# United States Patent and Trademark Office

This is the second office action for application number 10/697,379, System and Method for Mounting In-Vehicle Electronics, filed on October 30, 2003.

Patent number 5,850,078 to Giordano et al.

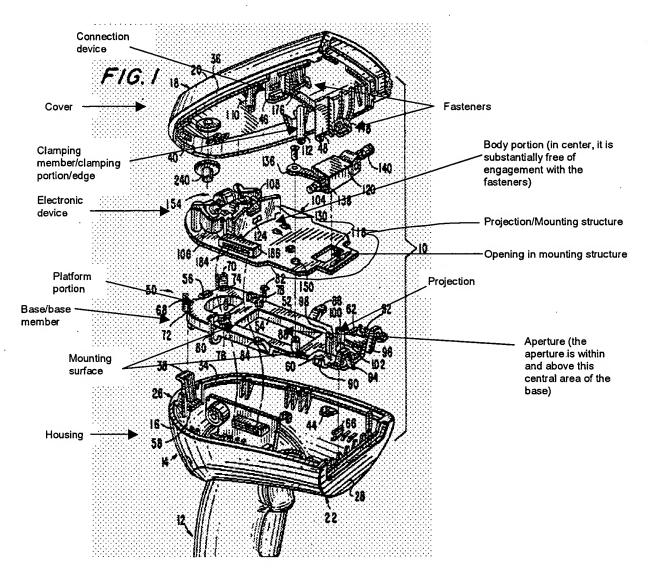
Claims 1-8 and 15-25 are rejected under 35 U.S.C. 102(b) as being anticipated by U.S.

Giordano et al. '078 discloses a mounting structure/system (above) comprising a base (above) with an aperture (above) therein, a cover (above) coupled to the base, wherein an electronic device (above) is configured to fit within the aperture and has at least one projection (above) extending between the base and the cover, wherein the base includes a platform portion (above, top of base, generally) having at least one mounting surface (above)

formed thereon adjacent the aperture and at least partially surrounding the aperture, wherein the cover further comprises a clamping member/portion comprising an edge of the cover (above, it inherently could act as a clamping member), wherein the cover is coupled to the base by fasteners (above), wherein the mounting surface could inherently position the electronic device at an angle relative to the base (inherently *some* angle), wherein the mounting surface includes a projection (above), wherein the cover further comprises at least one connection device for coupling the cover and the base member (indirectly, at least), wherein the system includes a housing (above) having a first attachment structure (58) for coupling to the base member and a second attachment structure (12) that could inherently couple to a overhead panel in a vehicle interior, wherein the mounting structure could inherently perform all claimed functions and be used with all objects/members functionally recited throughout the claims, wherein the underside of the body portion of the electronic device could inherently be free of contact with any component within the vehicle interior, wherein the body portion of the electronic device is substantially free of contact with the cover and the base member (see figure 3), wherein the base member or cover could inherently be mounted to a component in a vehicle interior.
